Product Change Notification

PCN26-3-K12S - Internal design improvements
and relocation of rubber boot assembly operation

C&K

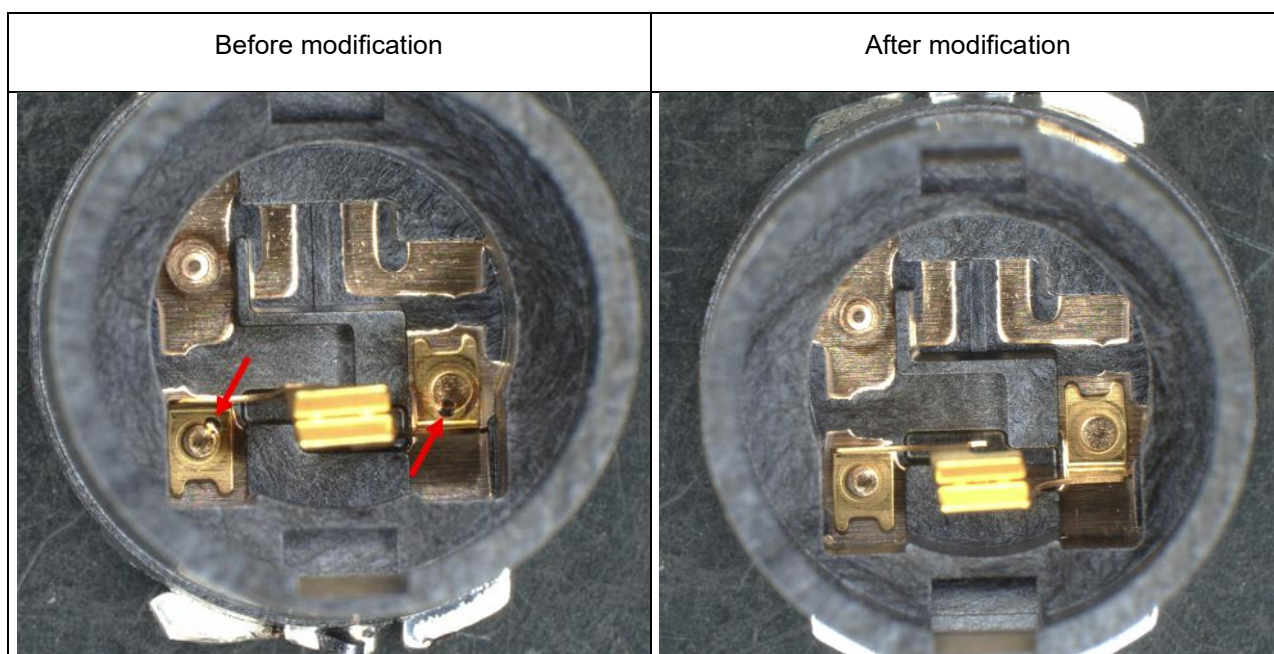
- Removal of the laser welding point for the Mobile Contact
- Widening of the landing pads for the LED soldering areas and change of solder paste type
- Relocation of the rubber boot assembly operation

2.1 Removal of the Contact Mobile laser soldering point

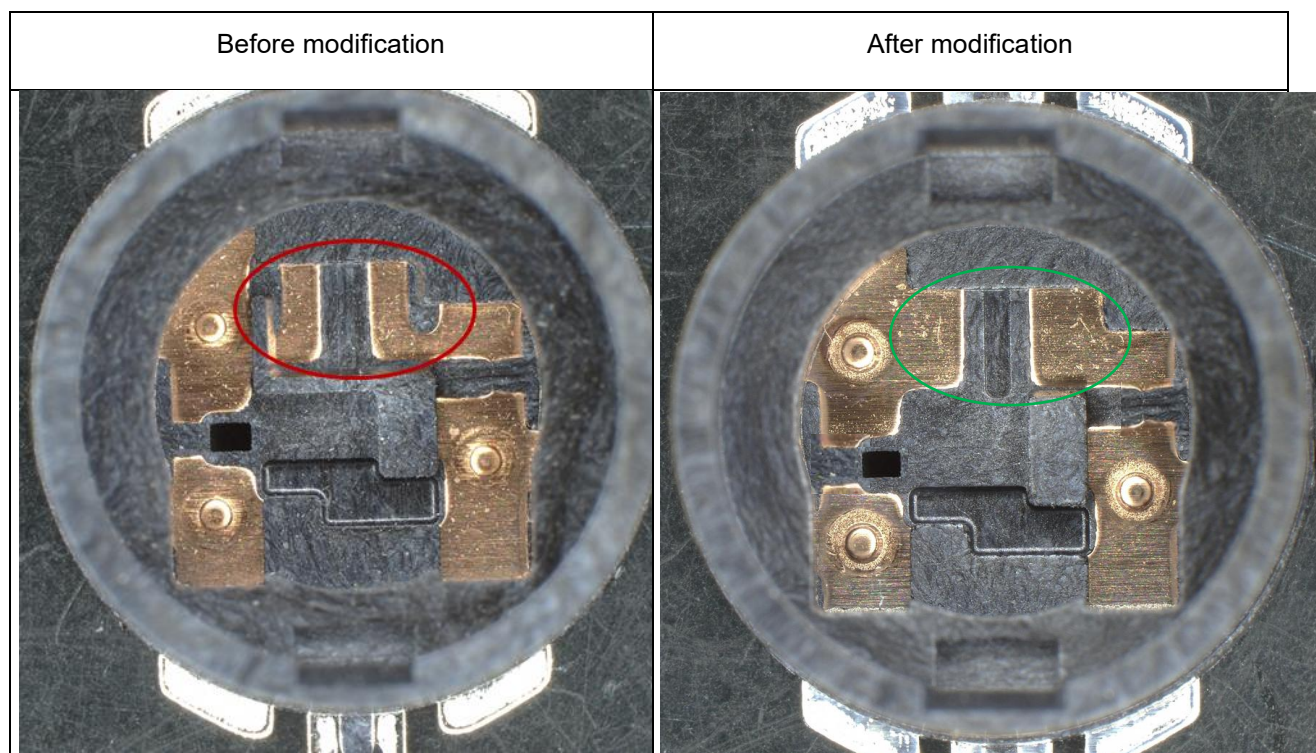
- Pull-out resistance: reduced dispersion and higher average values in the absence of laser welding: +7%
- Contact force: higher average values in the absence of laser welding: +14%
- Twisting resistance (anti-rotation): higher measured values in the absence of laser welding: +16%
